Perfect Brake Job. Every time.

MODELS: • PFM 9.2

**50-033**

## ● **Redesigned PFM 9.2 BELT COVER** **Change effective with serial # 9LX20379**

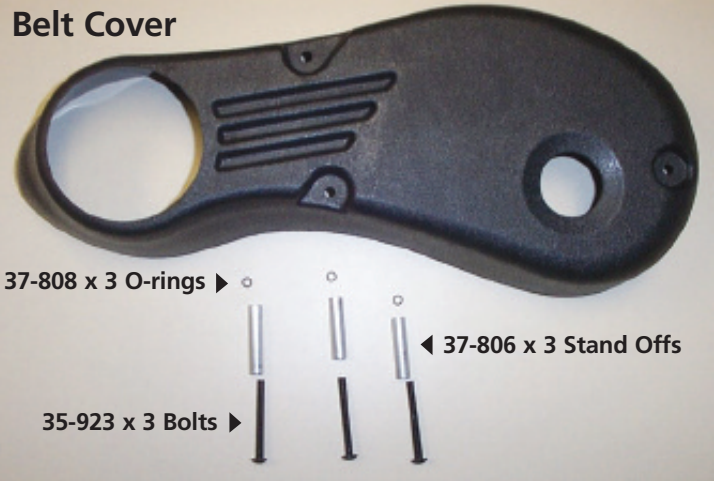
In our old age we've become just a bit more modest! That's one way of looking at this change to a completely redesigned belt cover. In an attempt to rectify fit issues; perception of quality of cog gears/belts as seen through the old clear belt cover; and difficulty in obtaining a straight view of the serial number in a dark shop; we've redesigned the belt cover using a solid black textured ABS plastic material and new structural design. Due to the manufacturing process, this new cover requires a different attachment method. The new cover uses 3 small aluminum stand offs held in place by small o-rings onto 3 button headed screws.

Send bolt through front of cover and place an aluminum stand off on the bolt followed by an o-ring to hold the stand off in place while you install the cover. Repeat twice more or until all bolts are through and have stand off and o-ring on them. Carefully center each bolt in its corresponding hole and tighten securely. The stand offs limit the amount the screw can go in and keep the screws from being over tightened.

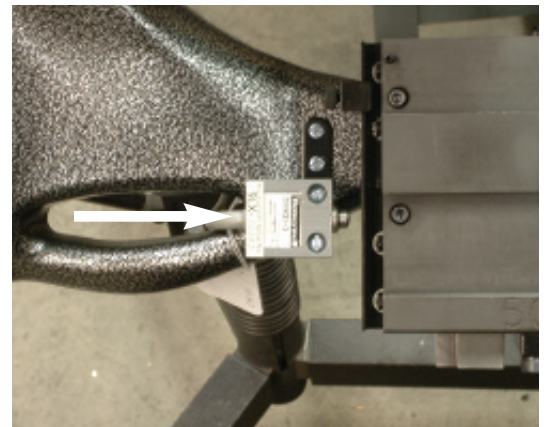
For everyone's convenience, there are now two locations for the serial number. The first will be located on the micro-switch and is designed primarily for the shipping dept. to identify lathes easily. Although this location is only stuck on, the adhesive is fairly strong and may stay in place quite some time. The second and most permanent location is on the underside of the lathe between the gear box and the clutch handle (hockey puck) and will be held in place by a rivet.

▶ New temporary shipping location for serial number on micro-switch

▶ New permanent serial number location underneath lathe
